**Section 16 Planning Application for Proposed Minor Relaxation of  
Building Height and Plot Ratio Restrictions  
for Permitted Public Housing Development at  
Long Bin, Yuen Long  
(Application no. A/YL-TYST/1285)**

**S.16 Application No. A/YL-TYST/1285**

**Responses to Comments**

**Figure D1 – Location of Key Cross Sections of the Yuen Long West Nullah**

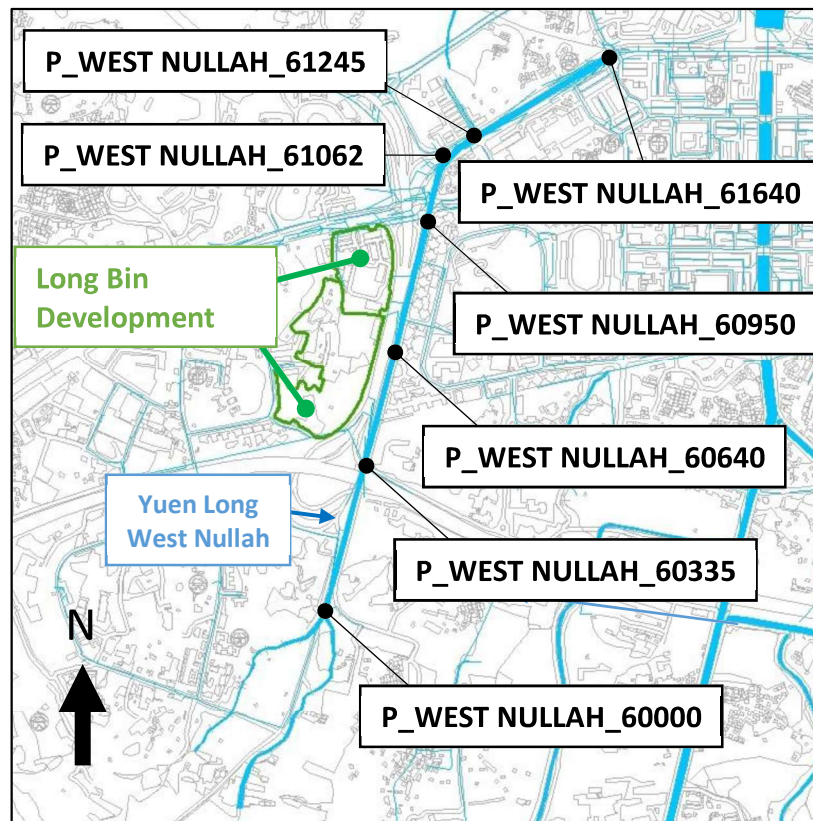
(b) Section 2.1: Climate change scenario of end-21st century with design allowance should be assessed according to Corrigendum No. 1/2022.	
	(c) Annex 2: Please justify the calculation of max. water level under latest design standard is valid. Please also indicate the percentage of the capacity reached for each section of the proposed and existing stormwater pipes for reference. According to Section 9.3 of Stormwater Drainage Manual, please ensure that suitable allowance should be made in the design for the deposition of sediment in stormwater channels and pipes.

<p>The sedimentation for proposed works (i.e. 10% reduction of flow area) has been considered in Appendix D of CEDD’s Revised Final DIA (<b>Attachment 2</b>).</p>	Location	Ground Level (mPD)	Max. water level of 50-year (mPD)	Freeboard (m)	Proposed_MHA01 (D1200)	6.00	5.52	0.48	Proposed_MHA02 (D1200)	6.00	5.49	0.51	Proposed_MHA03 (D1200)	6.00	5.31	0.69	Proposed_MHA04 (D900)	6.00	5.17	0.83	Proposed_MHA05 (D1350)	6.00	5.13	0.87	Proposed_MHA07 (Existing 2xD1350)	6.00	5.02	0.98	Proposed_MH_02 (D1200)	6.00	5.31	0.69	Proposed_MH_20 (D1200)	6.00	5.29	0.71	Proposed_MH_21 (D1200)	6.00	5.23	0.77	Proposed_MH_22 (D1200)	6.00	5.17	0.83	Proposed_MH_23 (D1200)	6.00	5.14	0.86	Proposed_MH_24 (D1200)	6.00	5.07	0.93	Proposed_MH_25 (D1200)	6.00	5.01	0.99
Location	Ground Level (mPD)	Max. water level of 50-year (mPD)	Freeboard (m)																																																							
Proposed_MHA01 (D1200)	6.00	5.52	0.48																																																							
Proposed_MHA02 (D1200)	6.00	5.49	0.51																																																							
Proposed_MHA03 (D1200)	6.00	5.31	0.69																																																							
Proposed_MHA04 (D900)	6.00	5.17	0.83																																																							
Proposed_MHA05 (D1350)	6.00	5.13	0.87																																																							
Proposed_MHA07 (Existing 2xD1350)	6.00	5.02	0.98																																																							
Proposed_MH_02 (D1200)	6.00	5.31	0.69																																																							
Proposed_MH_20 (D1200)	6.00	5.29	0.71																																																							
Proposed_MH_21 (D1200)	6.00	5.23	0.77																																																							
Proposed_MH_22 (D1200)	6.00	5.17	0.83																																																							
Proposed_MH_23 (D1200)	6.00	5.14	0.86																																																							
Proposed_MH_24 (D1200)	6.00	5.07	0.93																																																							
Proposed_MH_25 (D1200)	6.00	5.01	0.99

PROPOSED AND EXISTING  
SEWERAGE SYSTEM

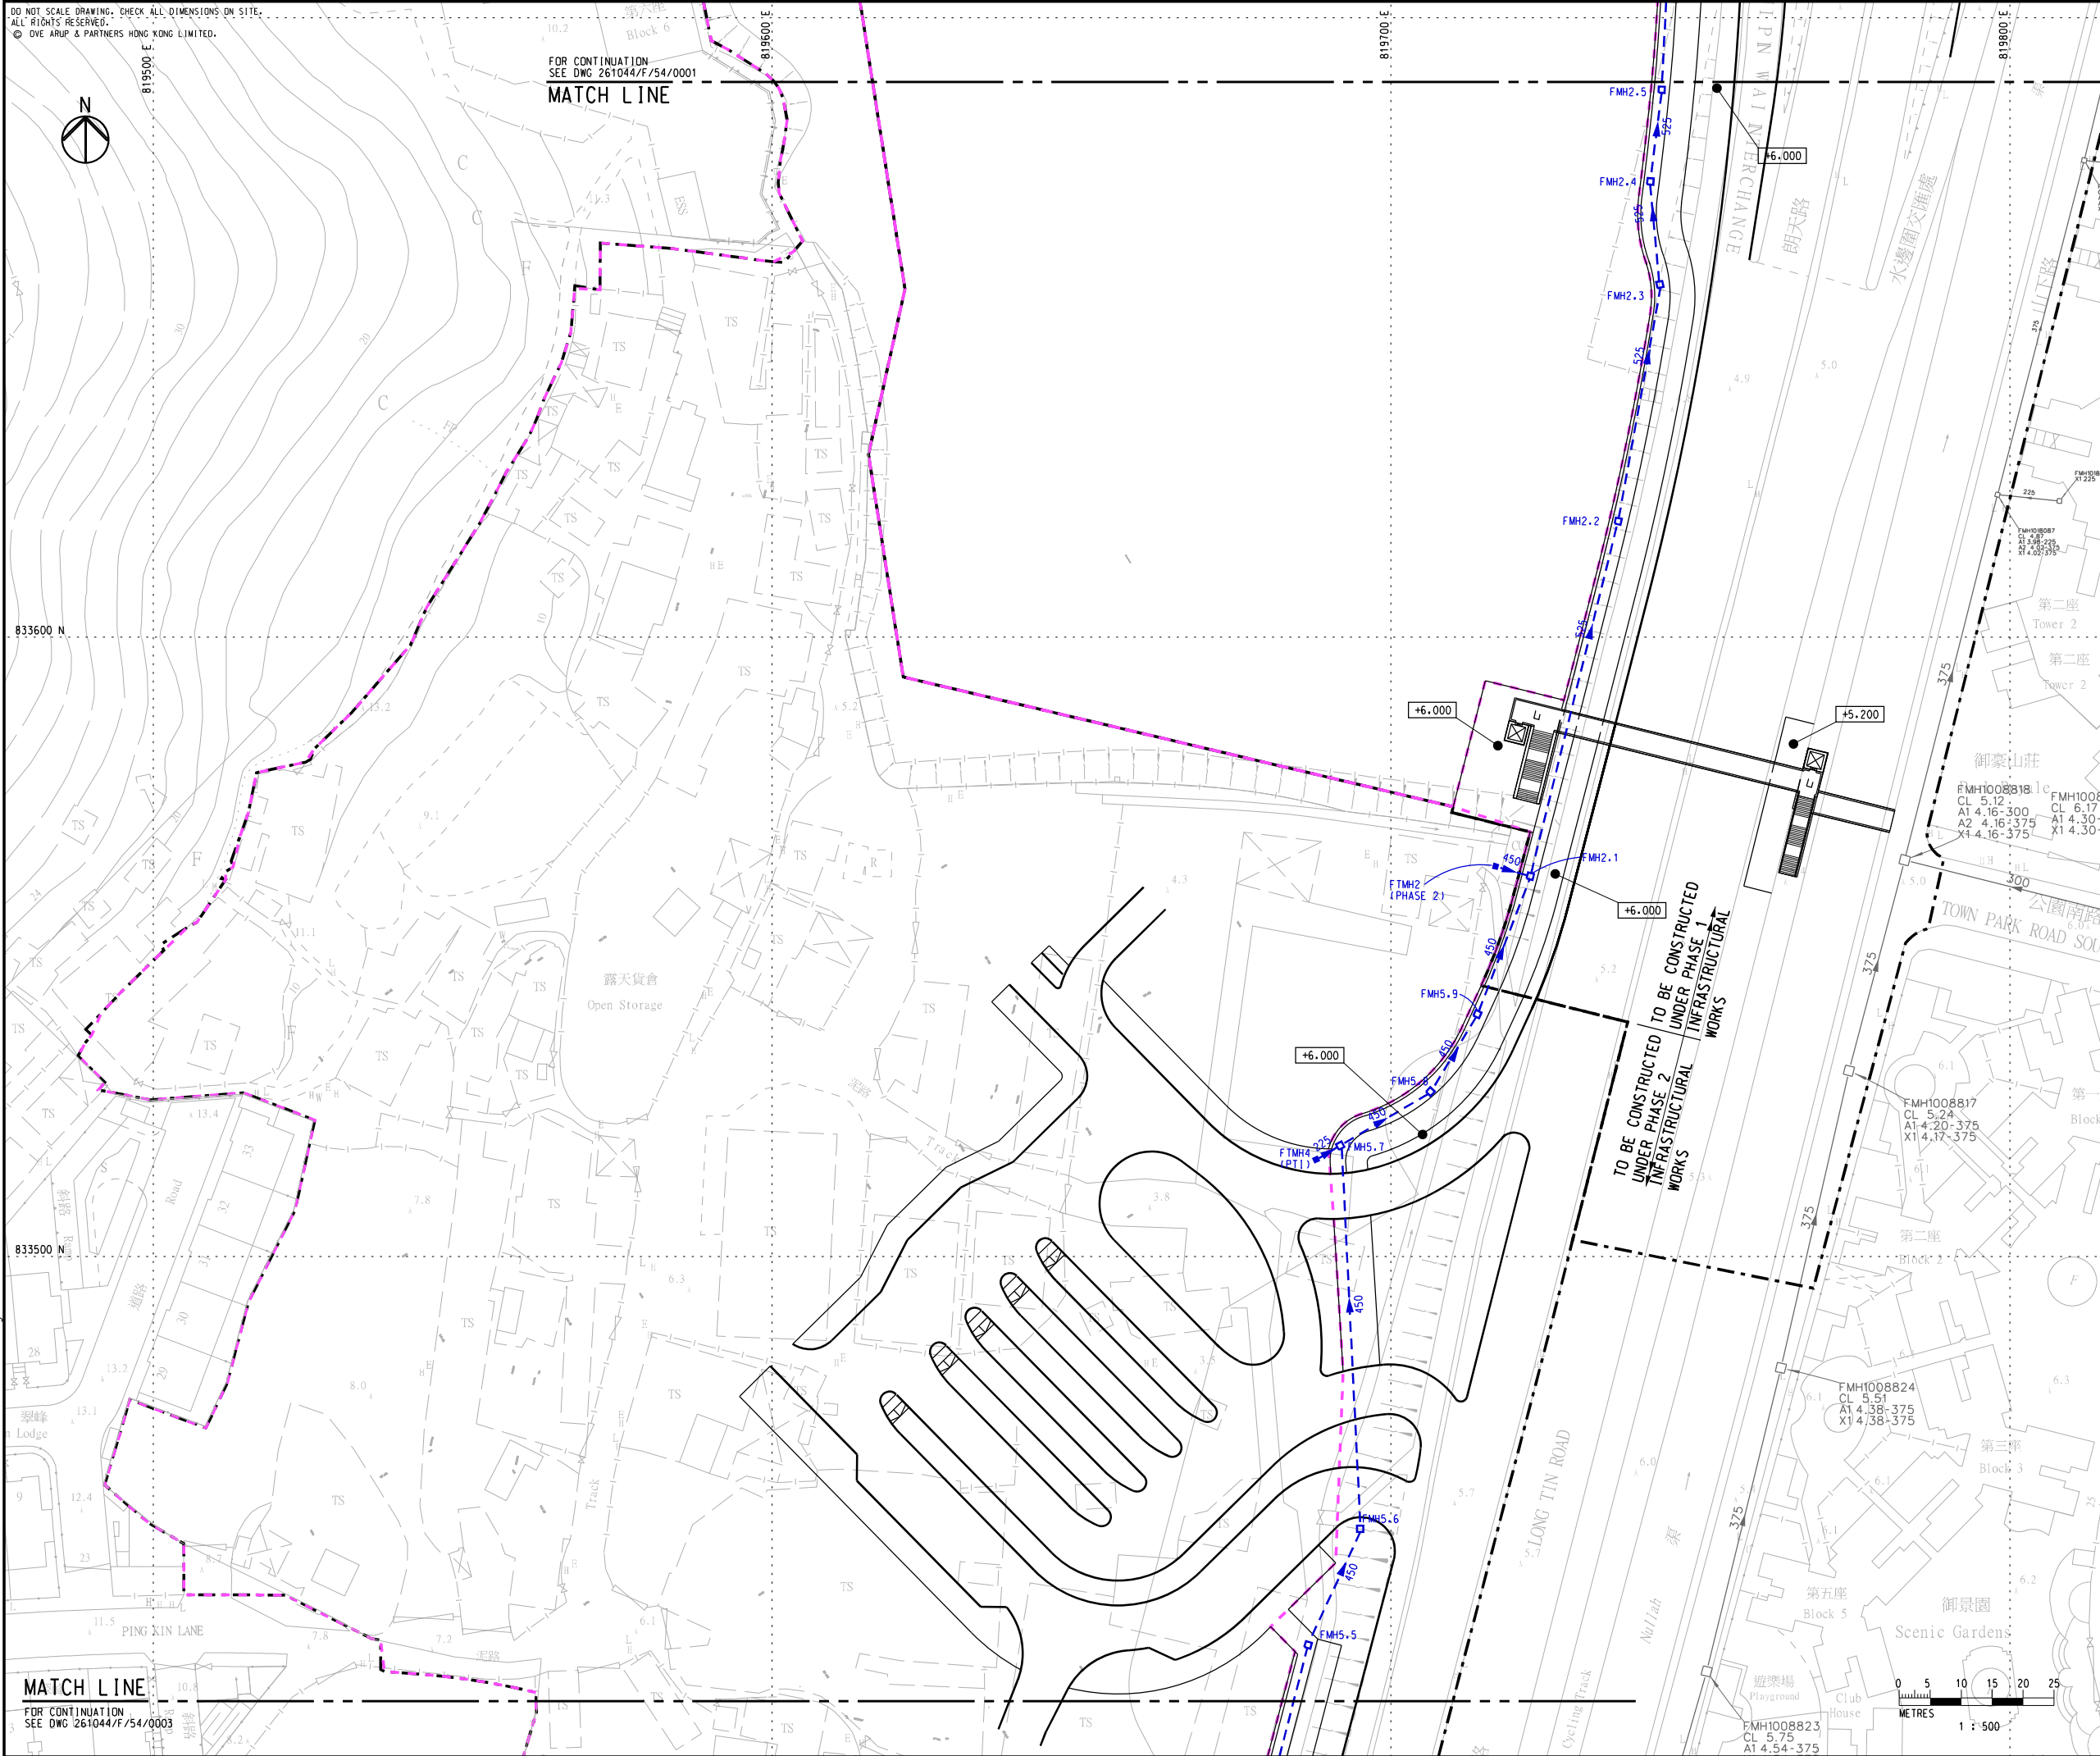
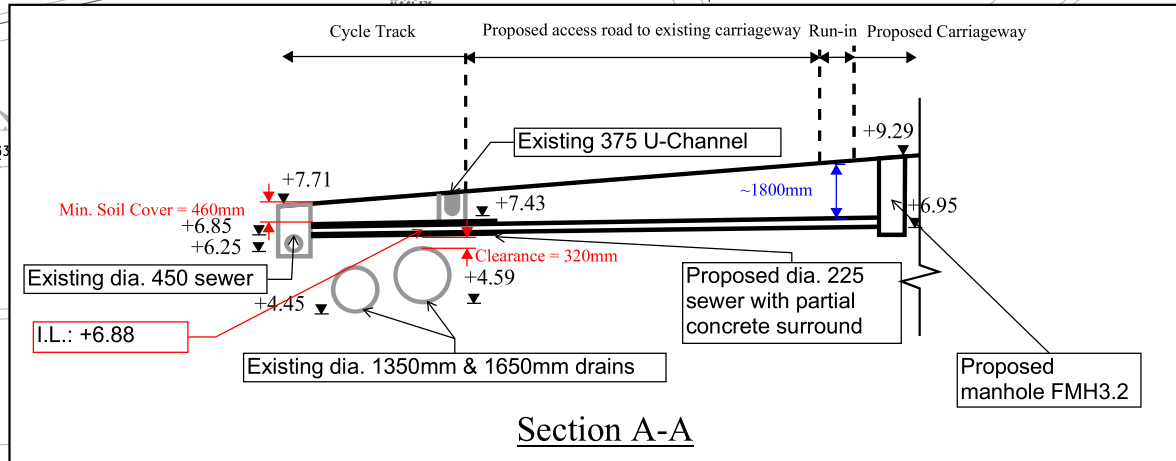
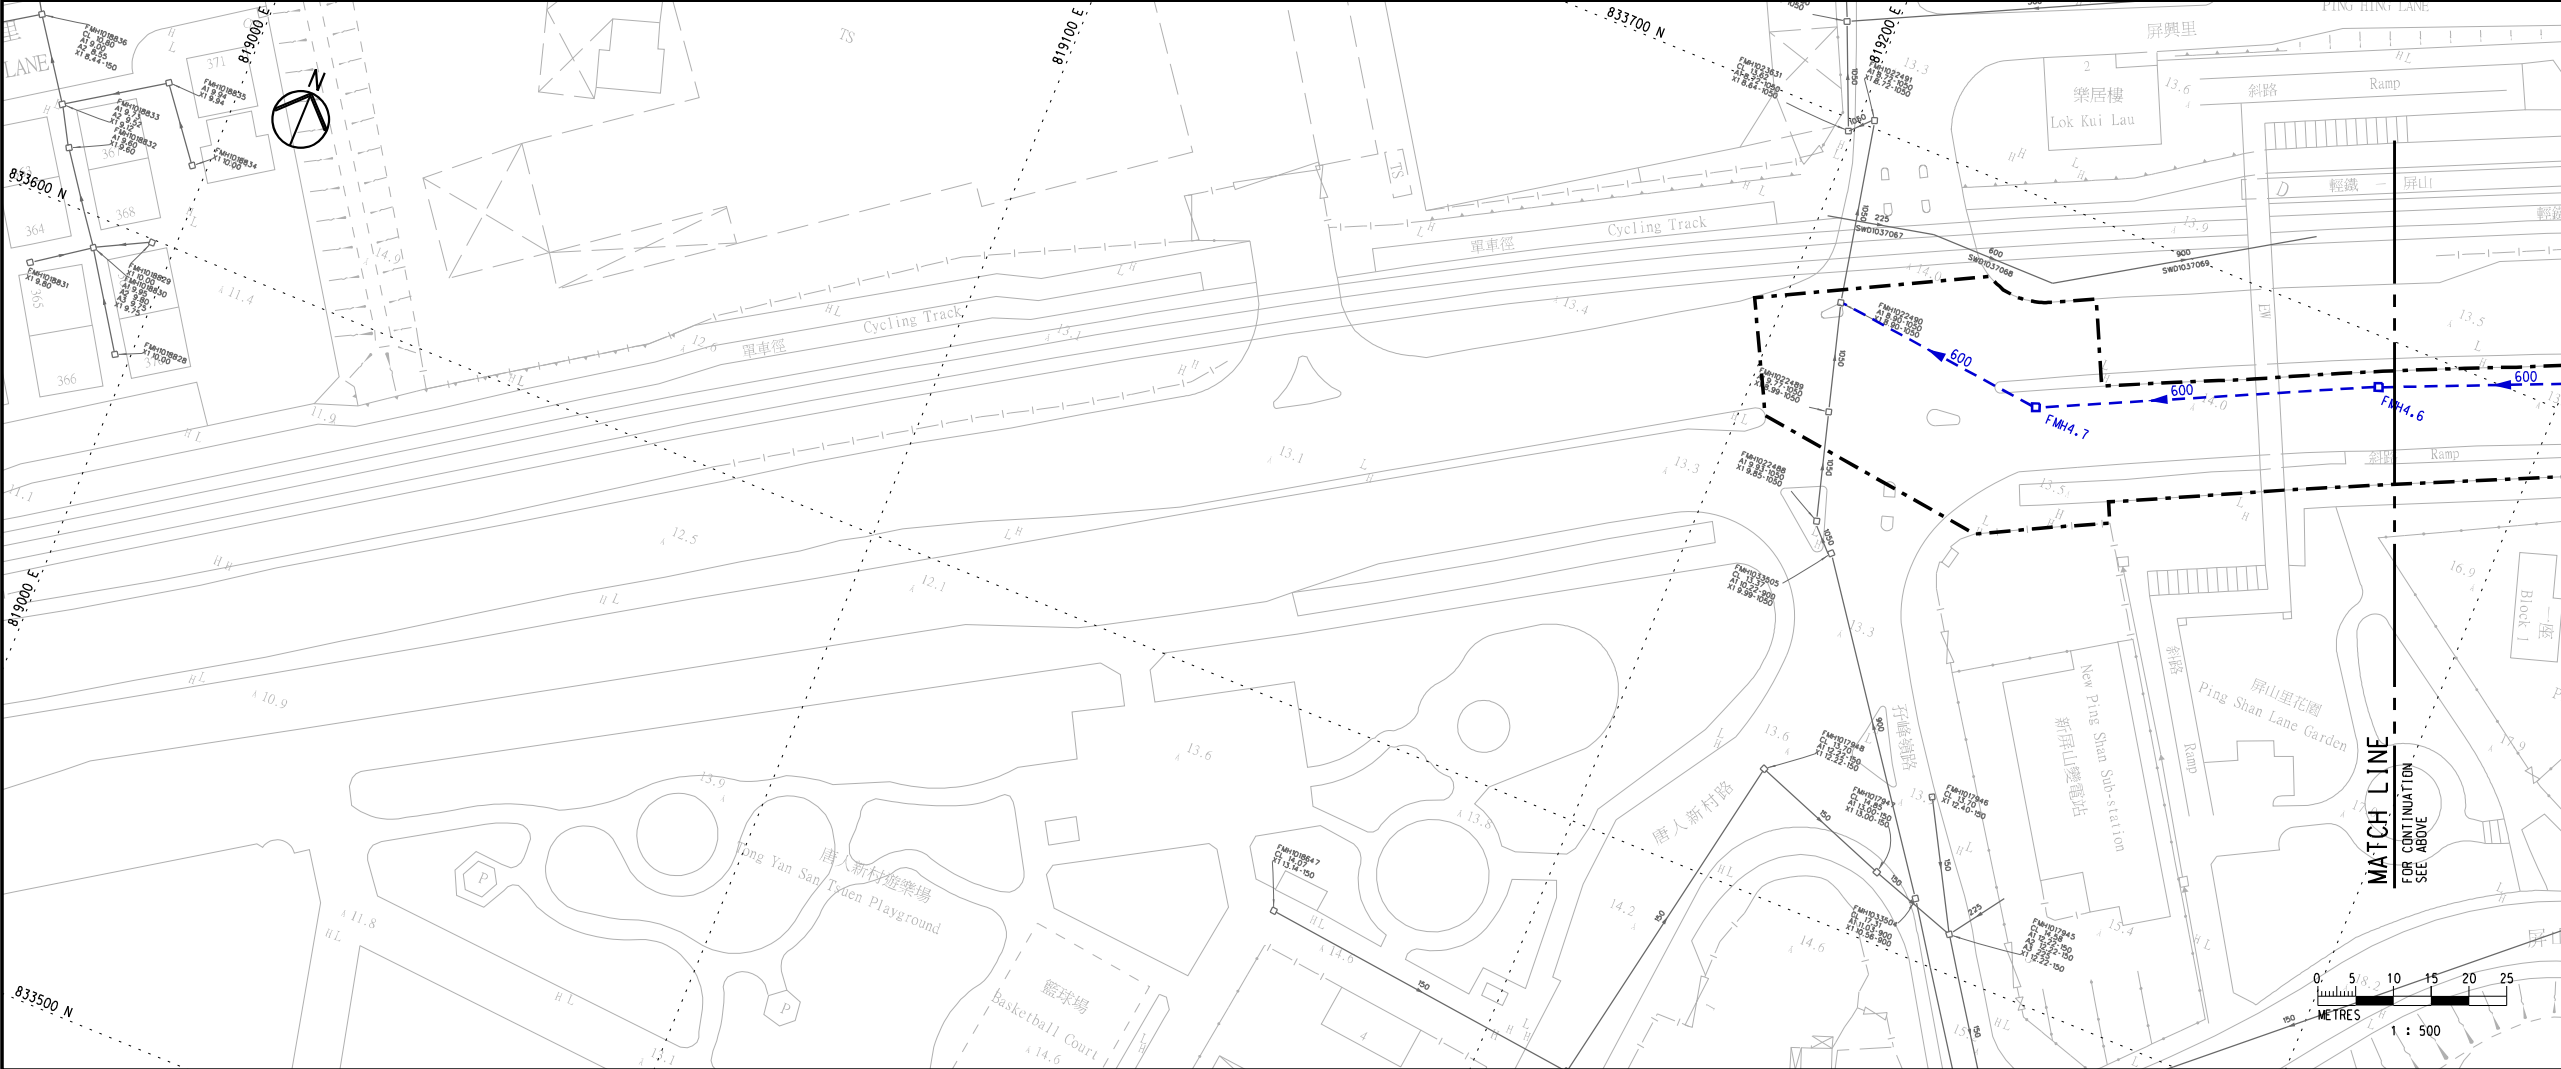
3. Figure 2: please show the proposed sewer in the layout plan.	Please refer to <b>Attachment 3</b> for the plans showing the proposed sewers (as extracted from the approved SIA study of CE 75/2017 (CE)).
